Re: Florida Power & Light Company
Proposed Turkey Point Units 6 and 7
Docket Nos. 52-040 and 52-041
Response to NRC Request for Additional Information Letter No. 082 (eRAI 7811)
SRP Section 02.05.04 – Stability of Subsurface Materials and Foundations

NRC RAI Letter No. PTN-RAI-LTR-082

NRC RAI Number: 02.05.04-28 (eRAI 7811)

Figure 1 Plot of Uncorrected SPT N Values versus the Summation of 3rd and 4th Blow Counts from the Supplemental Investigation

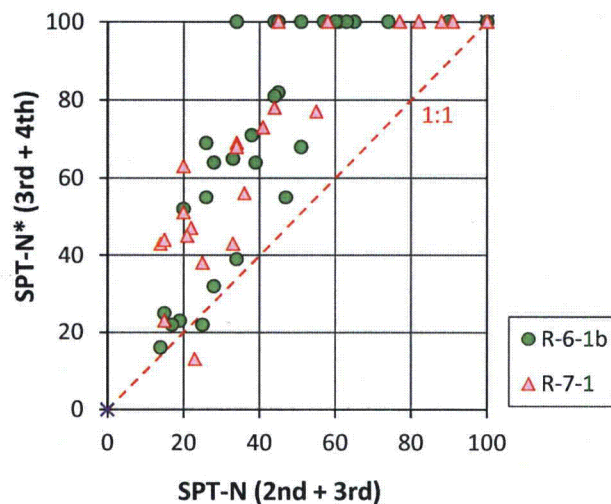
In response to RAI 02.05.04-2 and in FSAR Subsection 2.5.4.2.1.3.2.1 the applicant attributed the lower N-values to overwashing. The applicant demonstrated the overwashing effect by using the 24-inch sampler in its supplemental field investigation to display that the summations of 3rd and 4th blow counts are consistently higher than the summations of the 2nd and 3rd blow counts (SPT N-value). However, it is not clear why the "SPT N" values obtained from the supplemental investigation are consistently higher than those obtained during the initial investigation, given the similar condition of overwashing ahead of casing for both 18-inch sampler and 24-inch sampler. In accordance with 10 CFR 100.2, please provide insight into the difference between the original SPT N-values and the supplemental SPT N-values shown in Figure 2 of the RAI response.

From the results, it is recognized that the blow counts obtained with the use of the longer split barrel (intervals 3rd and 4th as opposed to 2nd and 3rd) are less impacted by the effects of overwashing as shown on Figure 1. However, it is acknowledged that the degree of disturbance cannot be fully eliminated.
